**CABINET MEMBER FOR ENVIRONMENT – 16 JANUARY 2020**  
**A415 BETWEEN ABINGDON AND MARCHAM: PROPOSED 50MPH**  
**SPEED LIMIT**

**Report by Interim Director for Community Operations**

3. This report presents responses received to a statutory consultation to introduce a 50mph speed limit on the A415 between Abingdon and Marcham.

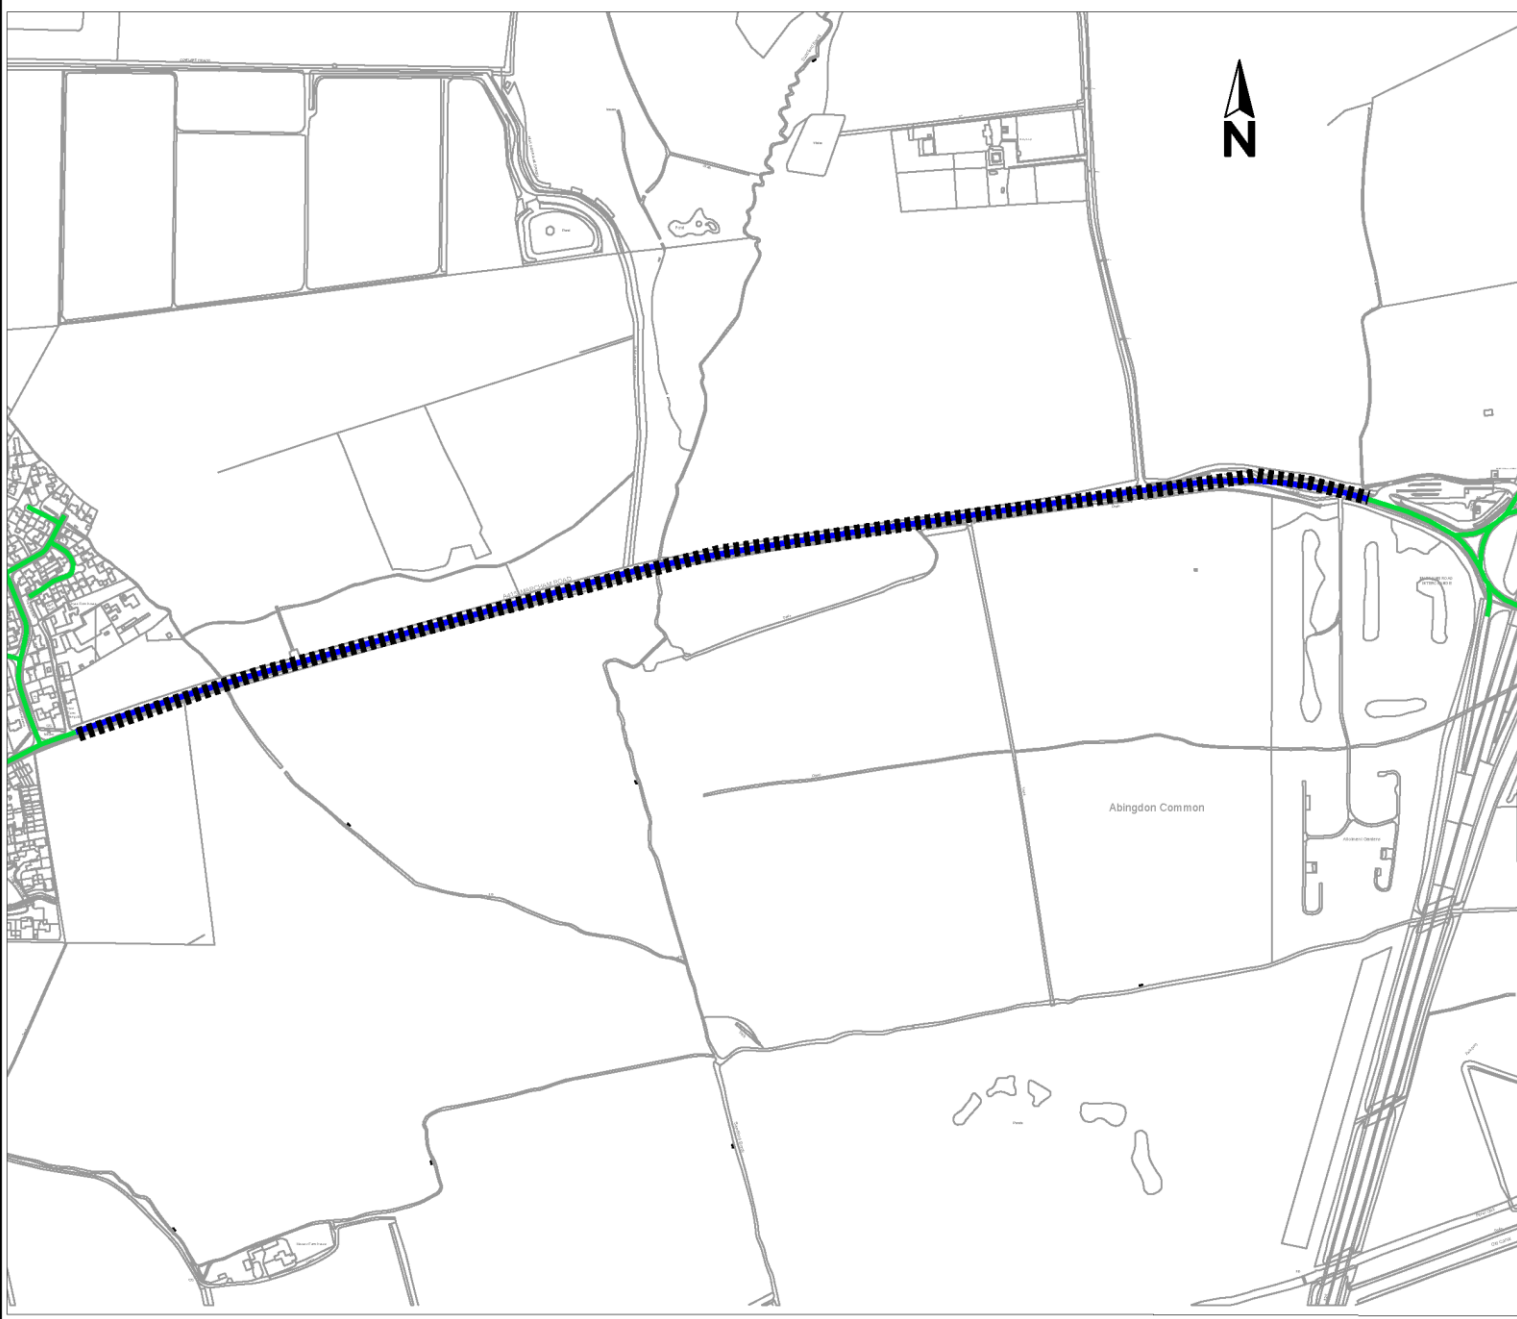
(3) Marcham Parish Council	<b>Support</b> - There is a combined footway / cycleway along the A415. Pedestrians are often walking next to large lorries, and other vehicles travelling at fast speeds. There is a chance of wing mirrors overhanging the footway. A speed reduction would make pedestrians at less risk from fast moving traffic and enable them to feel safer.

(4) Local Resident, (Marcham)	<b>Object</b> - It is simply not necessary to reduce the speed limit along the proposed road. Traffic accidents as a result of the current speed limit are minimal and a reduction to 50mph would increase congestion.

(5) Local Resident, (Marcham)	<b>Object</b> - Having lived in Marcham for over 15 years I know this road well. This road is already safe. There are almost no accidents. I have seen little evidence of speeding on this road. A lower speed limit would only serve to slow traffic when there is no need. When its busy, traffic density reduces the average speed already. Let's not spend money changing something that's not broken. I'm sure the council have higher priorities in these frugal times.

(6) Local Resident, (Drayton)	<b>Object</b> - Unofficial restrictions are already in place, by the numbers of drivers who think National Speed Limit means 50mph, drivers who drive along the A415 at 40mph (and continue at 40mph through the 30mph speed limits at either end) and by cyclists who refuse to use the cycle lane provided.  If any improvements to safety should be made, then it would be to install traffic lights at the Dalton Barracks turn off (where the accident blackspot is).

<p>(7) Local Resident, (Marcham)</p>	<p><b>Object</b> - I do not think that reducing the speed limit by 10mph will make any difference. It will also cost money to replace the signs. There is a clear 30mph sign going into the village, so people just need to stick to that! If anything, that sign could be moved further forward so that speed is reduced sooner...</p>
<p>(8) Local Resident, (Marcham)</p>	<p><b>Support</b> - I have seen a car collide with a family of roe deer that jumped out of the dense wooded area at the side of the road. It was a miracle that the driver did not swerve into the path of an oncoming vehicle coming the other way.</p> <p>The road is quite narrow leaving little room for error or lapses of concentration with the potential of a 120mph collision with oncoming traffic.</p> <p>The combined footpath and cycle path is too narrow to safely allow cyclists to pass in opposite directions or avoid a pedestrian safely. Side draft from large vehicles is strong enough at 60mph to knock cyclists or pedestrians off balance.</p> <p>Traffic struggles to judge when to decelerate on entering the Marcham 30mph area and this can lead to tailgating.</p> <p>I would also like to see a 40mph limit for suitable distance before Marcham to encourage traffic to decelerate adequately to meet the village 30mph limit.</p>

<p>(9) Local Resident, (Abingdon)</p>	<p><b>Support</b> - No comments.</p>
<p>(10) Local Resident, (Marcham)</p>	<p><b>Support</b> - This speed limit will only work if enforced properly - so speed cameras should be installed. Following assessment, a reduction to 40mph should be considered.</p>
<p>(11) Local Resident, (Marcham)</p>	<p><b>Support</b> - I nearly ticked "Object" as I would much rather it be a 40mph please. As a cyclist and a regular user of the cycle track alongside the A415 between Marcham and Abingdon, I can't tell you how scary it is when traffic is hurtling towards you at 60mph+, with their lights dazzling you at night and are only 1m or so away from you. If you meet someone coming the other way (on the "path") or get behind someone then you have to stop as there's precious little room to get by someone, making the busy, fast road by you even more threatening and unnerving. I know this consultation is about the road and its speed limit but please bear in mind those having to cycle by it.</p>

<p>My other concern is having to regularly turn right in to Howard Cornish Road in Marcham (in my car) and having traffic pile up behind me often braking at the last minute as they're going so fast. There has been a number of accidents at this junction (often due to the speed of drivers from 60mph limit). Sadly some drivers see the 30mph sign in Marcham as the place to start braking (in the run down to the corner) rather than slowing to 30mph for the speed limit. Finally, the Dalton Barracks turn off the A415 between Marcham and Abingdon is a shambles and often there's shunts there. People trying to turn right out of that junction take their life into their hands due to the speed of some drivers coming from both directions. Personally I'd make it a roundabout but as your consultation is asking about a speed limit then a 50mph (and certainly 40mph) would help.</p>

(12) Local Resident, (Oxford)	<b>Support</b> - The speed limit ought to be reduced further.
(13) Local Resident, (Marcham)	<b>Support</b> - A speed camera is also needed. There has been a fatality on the road. Many cars go above 60 already. When I walk along the path it does not feel safe.

(14) Local Resident, (Marcham)	<b>Support</b> - No comments.
(15) Local Resident, (Marcham)	<b>Support</b> - I fully support the reduction, and wish it was 40mph because of the danger to cyclists and pedestrians who use the now, overgrown narrow footpath to Abingdon. It is so dangerous when one gets large lorries thundering along the road. It would also reduce the speed on the entrance to the village - with the new housing estates on the main road there is a danger to children who have to use this route to school. There maybe logical reasons to reduce to 50mph but do these take into account the health and safety of persons who have to use footpaths along this very dangerous and busy route.

<p>(18) Local Resident, (Marcham)</p>	<p><b>Support</b> - Should be reduced to 40mph</p>
<p>(19) Local Resident, (Marcham)</p>	<p><b>Support</b> - I strongly feel 60mph is too fast for this road. It is a short stretch from Abingdon to Marcham, and people are unprepared to slow down for Marcham's 30mph.</p> <p>I am always afraid and keep my foot on my brake pedal to warn people coming behind me when waiting to turn right into Howard Cornish. I know of at least two people who have had a car go into the back of them at that point by people speeding towards Marcham, and not realising a car has stopped to turn right until too late.</p> <p>Cars going at 60mph and above are also very unpleasant for pedestrians and cyclists on the footpath. There is also a slightly tricky wiggle in the road early on from Abingdon to Marcham and going at 60mph at night makes it tricky for the unprepared, and I think dangerous.</p> <p>I find it really surprising that most of the road from Frilford to Wantage is 50mph, when this stretch is 60mph. With the turning to Shippon, and the need to slow down for Marcham, I strongly feel this stretch has as much or more need to be 50mph.</p>

<p>(20) Local Resident, (Abingdon)</p>	<p><b>Support</b> - The speed of some drivers, especially HGVs, on the A415 from Abingdon to Marcham is excessive for the conditions of the road and should be reduced and there should be further restrictions through the village of Marcham i.e. speed cameras as many drivers ignore the 30mph limit. My family has been subject to 'near misses' on the pedestrian crossing adjacent to the cross-road on many occasions.</p> <p>The volume of traffic during the rush-hours makes it difficult to egress from side-roads on to the A415.</p>
<p>(21) Local Resident, (Marcham)</p>	<p><b>Support</b> - It should be 40 MPH, like the Drayton to Abingdon Road. This is for SAFETY reasons and to ENCOURAGE walkers and cyclists to use the footpath feeling safe. = GREEN POLICY?!?!?! please..... Secondly please consider SIGNS to drivers exiting the A34 (northbound) that there is a CYCLE PATH crossing the road at the roundabout junction with A415.</p>

11. Overall the balance of opinion is clearly supportive of the proposal. In respect of the requests to consider a 40mph speed limit, a speed survey carried out in June 2019 showed average speeds of 48 mph indicating that the proposed 50mph speed limit was appropriate taking account the character of the road and that a 40mph speed limit would only be viable if significant supporting measures were also to be provided, for which there is currently no funding.
